***Woodroffe TS – Replacing T1, T2, T3, T4 with new T3 and T4
CAA ID Number: 2007-EX367***

**Final Report - Expedited System Impact Assessment
Hydro One Networks Inc.**

Figure 1 - Woodroffe TS Historic Load (T1, T2, T3 & T4)

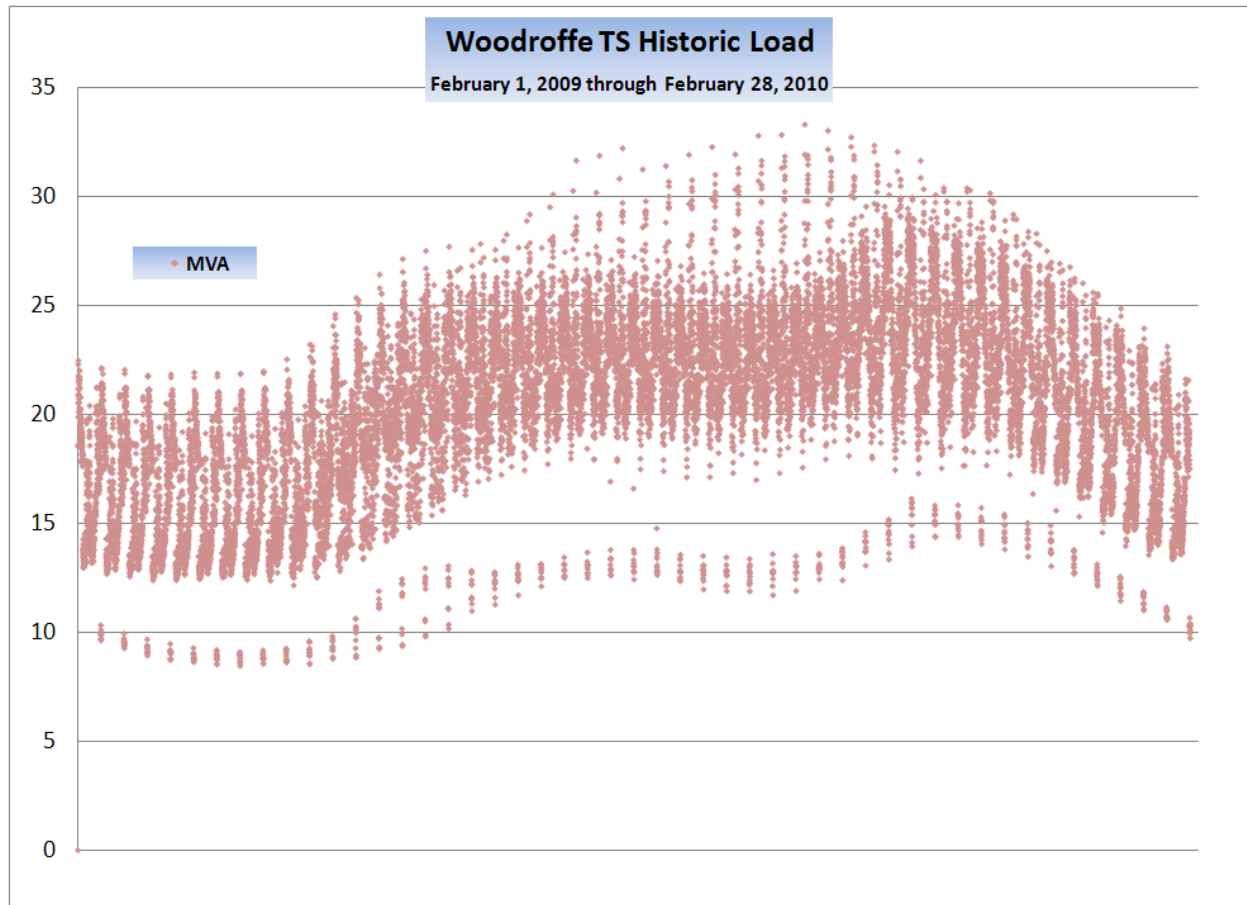
Figure 1 shows the historic load on T1, T2, T3, and T4 at Woodroffe TS. The peak load on the 4 transformers as measured on the LV side of the transformers for the period between February 1, 2009 and February 28, 2010 was 33.3 MVA and occurred on June 25, 2009 at 1600.

The peak load at Woodroffe TS is projected to increase by 1% per year. The continuous ratings of either of the replacement transformers will be more than adequate to carry this projected peak load until well in the future.

Figure 2 - Load Angle at Woodroffe TS

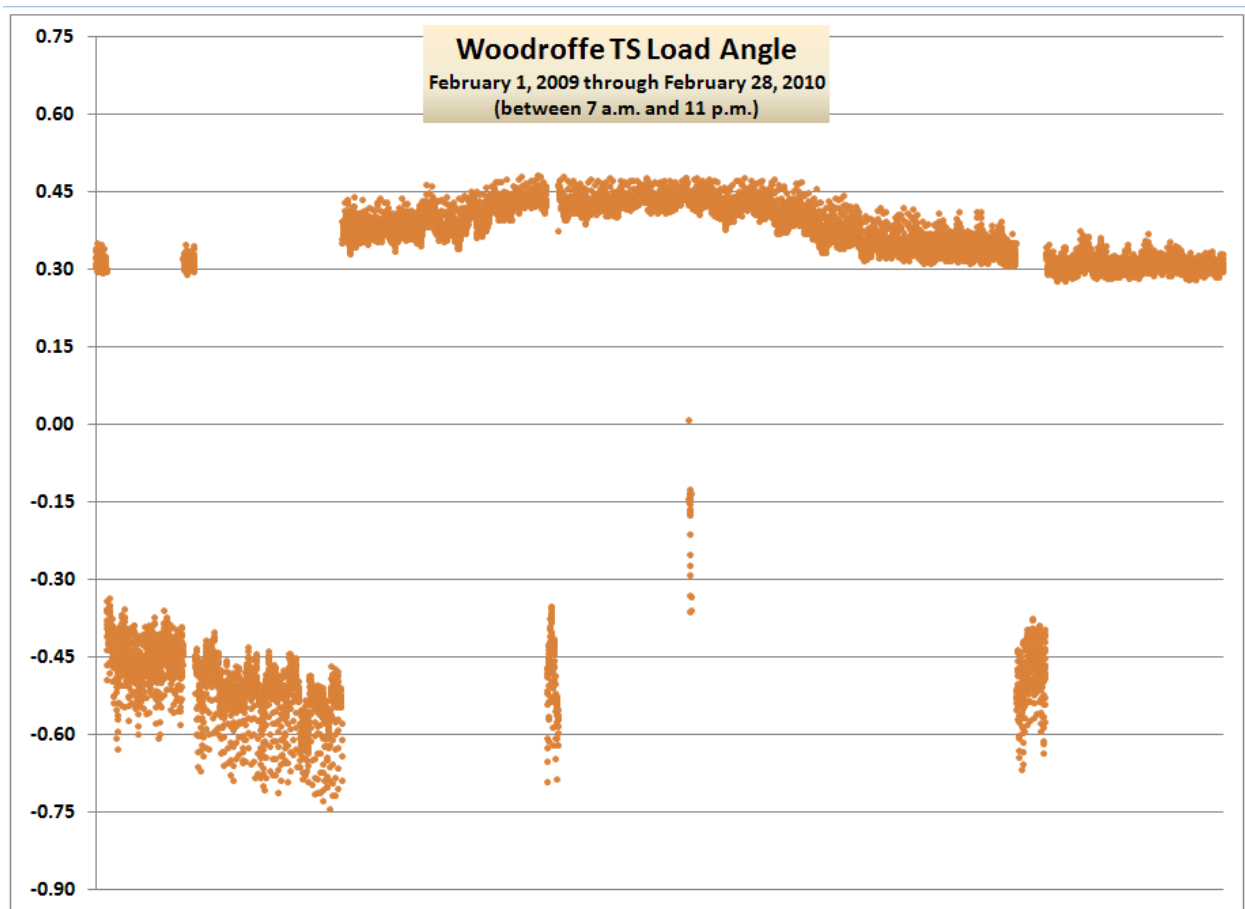
Between February 1, 2009 and February 28, 2010 the highest load angle of 0.4822 radians at Woodroffe TS occurred on June 27, 2009 at 2300. Neither SC1 nor SC5.6 were in service on June 27, 2009 at 2300 and as a result were not providing any reactive compensation. Since SC1 and SC 5.6 are capable of providing the required reactive compensation, no additional shunt capacitors are required; however, the deployment strategy of the existing shunts needs to be revisited, so that the power factor requirements are met.

The IESO requires that Hydro One monitor the load angle at this station and if there are occurrences above 0.45 then Hydro One must implement correction measures at this station as soon as practical.
